Report of Chief Executive

Strategic Housing Development

Development Address: 'Barrington Tower', Brennanstown Road, Dublin 18.

ABP Reference: ABP31328122

Figure 5-3 | Site Accessibility - Walking Distance.

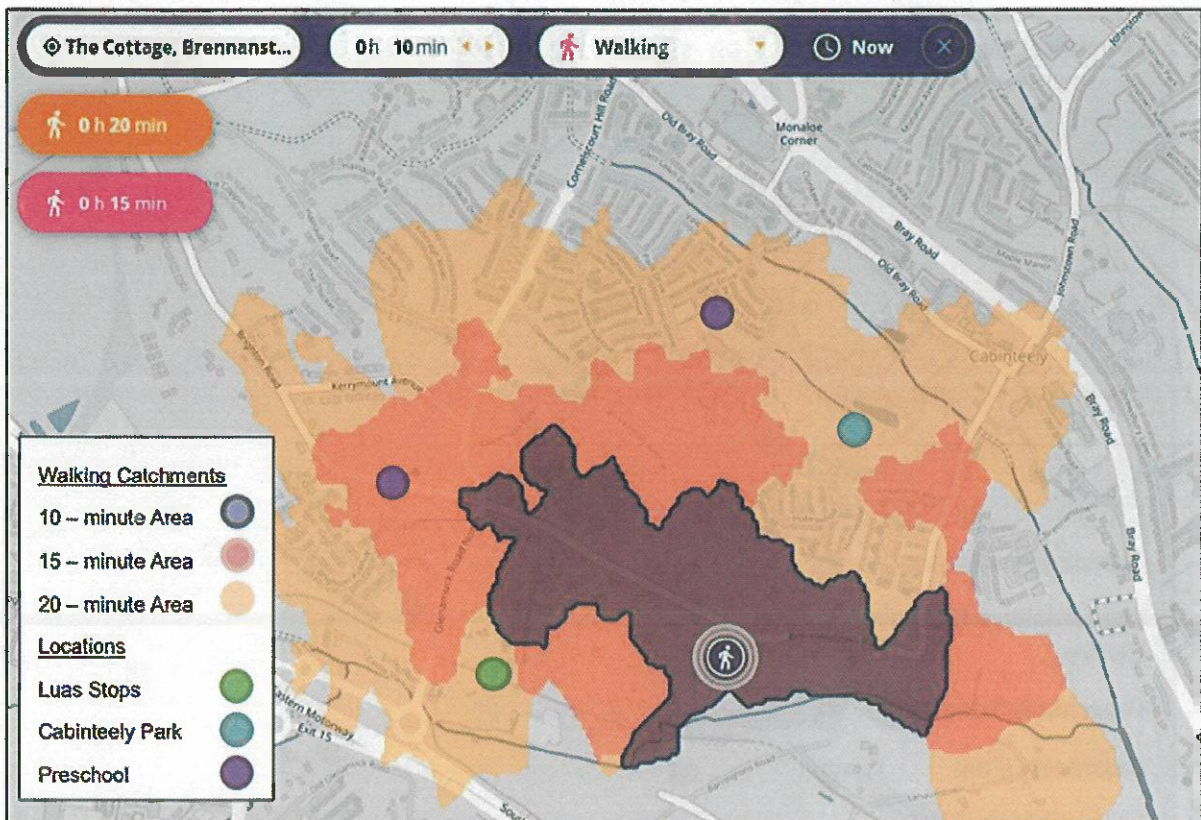
Transportation is uncertain that the provided walking and cycling distances maps accurate, considering the lack of pedestrian and cycling infrastructure, which would imply that areas to the east are not accessible in a safe manner. There are mainly noted in the submitted images (extracted from report) as follows:
